December 5, 2016

Re: ECS Project 18.4296  
Laboratory B1 Subgrade  
VA Campus, Lebanon, PA

SITE PHOTOGRAPHS  
November 2016

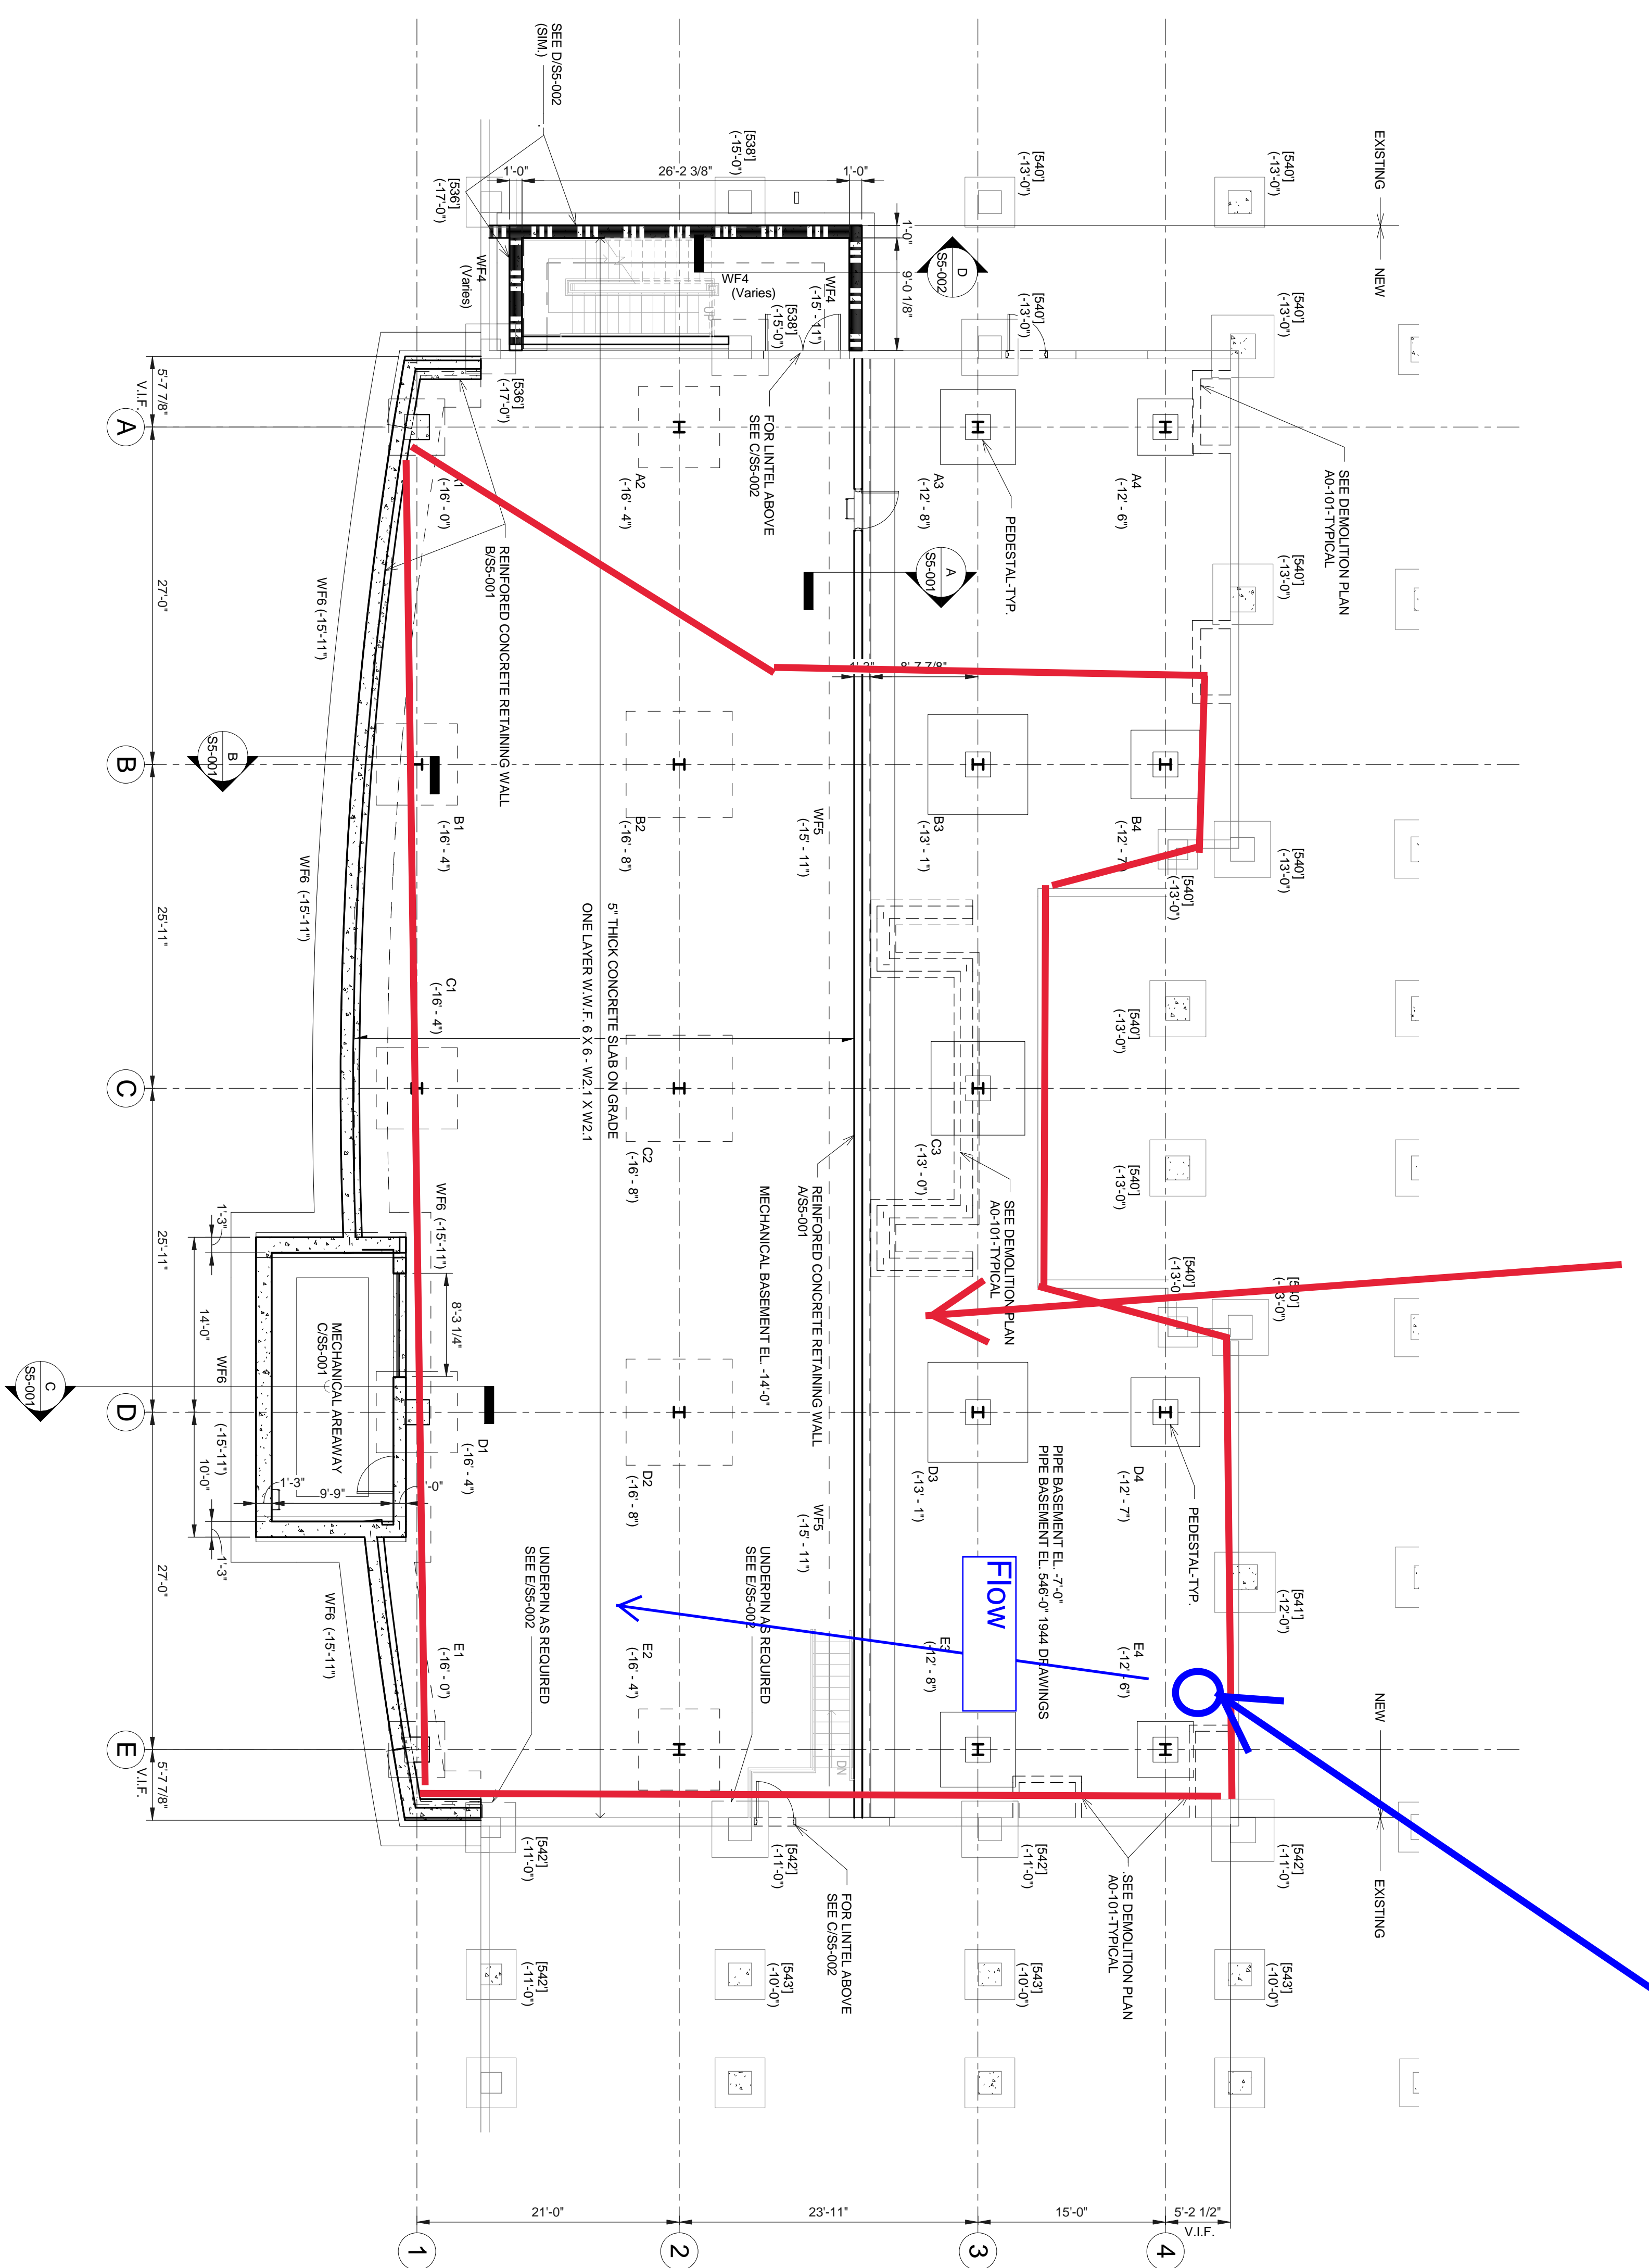
The ECS Geotechnical Engineer, J. Matthew Carroll, P.E., visited the site on November 22, 2016 to observe the site conditions. The conditions observed are documented in the attached photographs. In summary, the majority of the building footprint, primarily consisting of a below-grade laboratory, had been excavated to the rough subgrade elevation prior to our arrival. The approximate extents of our observation of the subgrade are depicted on the attached plan. ECS performed visual observation of the ground conditions and performed limited hand-probing of select locations while on-site. The unexcavated portion of the Laboratory B1 addition footprint appears to include some soil areas, which is apparently why they were not excavated previously, in order to preserve the subgrade and avoid unnecessarily exposing existing foundation elements to weather events and potential deterioration.

The ECS Engineer visited the site to observe the site conditions, with an emphasis on evaluating the condition of the bedrock in the excavation for support of the proposed structure. The rough grading at the site appears to have included several feet of rock removal, with the exposed excavation sidewalls consisting of massive, hard, and intact limestone bedrock. In several areas, the foundations supporting the existing Building No.1, a 6-8 story hospital building were observed to be bearing directly on the bedrock. The bottom of the excavation had some areas of surficial loose aggregate-sized pieces and areas of shallow standing water. Hand probing was performed in these areas to explore for the presence of fractures or voids, but none were identified. Some seepage into the excavation was observed as coming from underneath the existing Building 1 in the southeast corner (see sketch). As previously mentioned, the north side of the excavation had not yet been completed due to the greater apparent percentage of soil.

It is our opinion that the site preparation can be completed and the proposed Laboratory B1 addition can be constructed in accordance with the project plans, specifications, and the Geotechnical Report. ECS recommends that a representative of ECS be on-site to observe and document all of the foundation subgrade preparation, in order to verify that the subgrade is comprised of intact bedrock that is free of seams and voids that could affect foundation performance. The subgrade at the bottom of the excavation should be monitored and proof rolled with the heaviest roller/equipment that can access the excavation in order to facilitate this evaluation. In addition, we recommend that all below grade walls and the slab be protected from water intrusion with appropriate waterproofing measures. It is especially recommended that the new addition include a sump pump to remove groundwater seepage from beneath the building. If a sump pump system is not used to collect and remove groundwater seepage, water intrusion and related damages could occur in the new addition. Full design plans were not provided for our review, so it is not known if this is already incorporated into the design. Functionality of the sump system will also require the use of clean stone beneath the concrete slab to facilitate movement of the water to the sump location. ECS should be contacted to discuss additional details of this system if a sump is not already included in the design.

Based on our observations, the bedrock at this site is capable of providing the required 10,000 psf bearing capacity. The bearing conditions at all foundation areas should be verified prior to placement of reinforcing steel and concrete. Soil seams, rock fractures, or voids will require attention and repair prior to foundation placement, if encountered.

Drawing Title  
**Mechanical  
Basement-Foundation Plan**

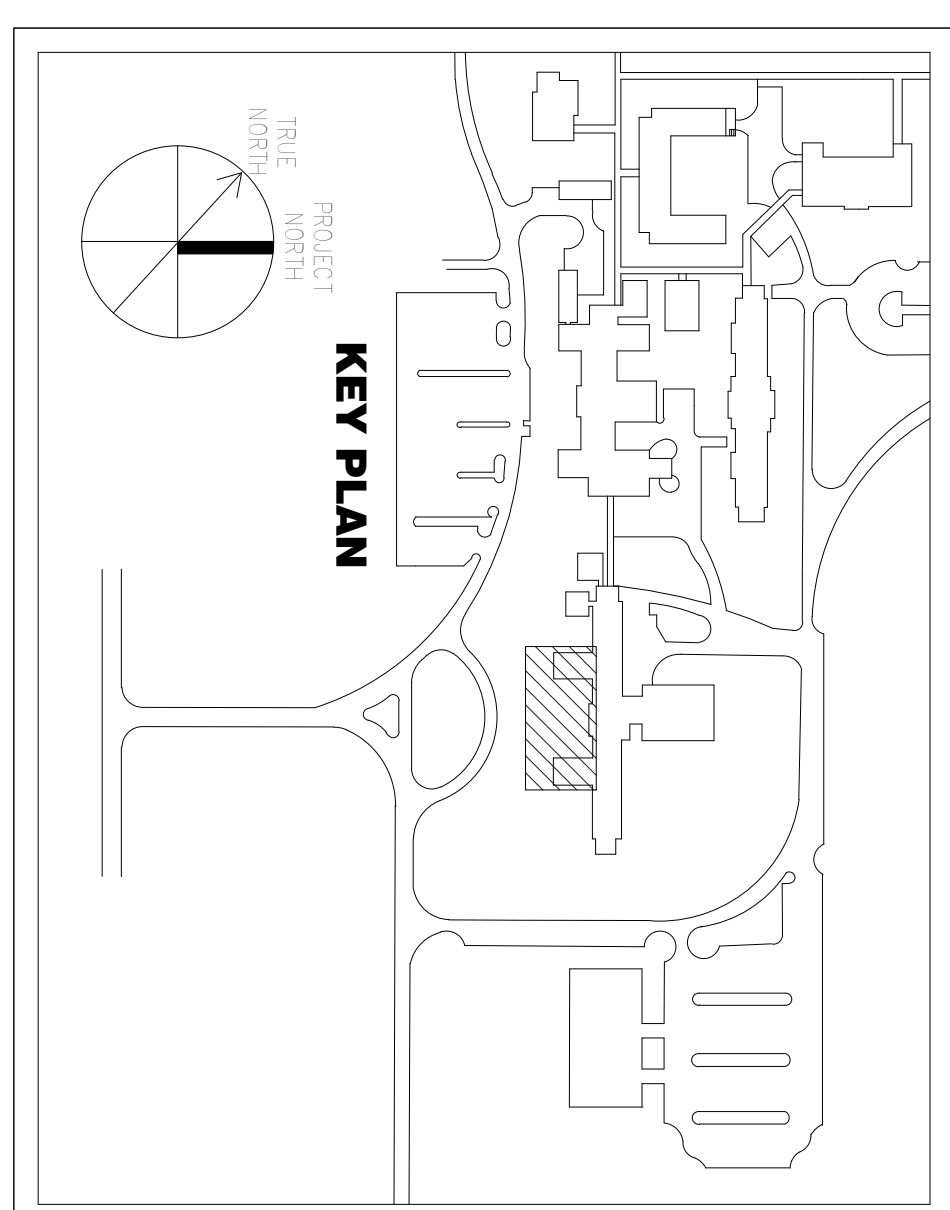
Approximate Extents of Excavated Area

Water Seepage Observed
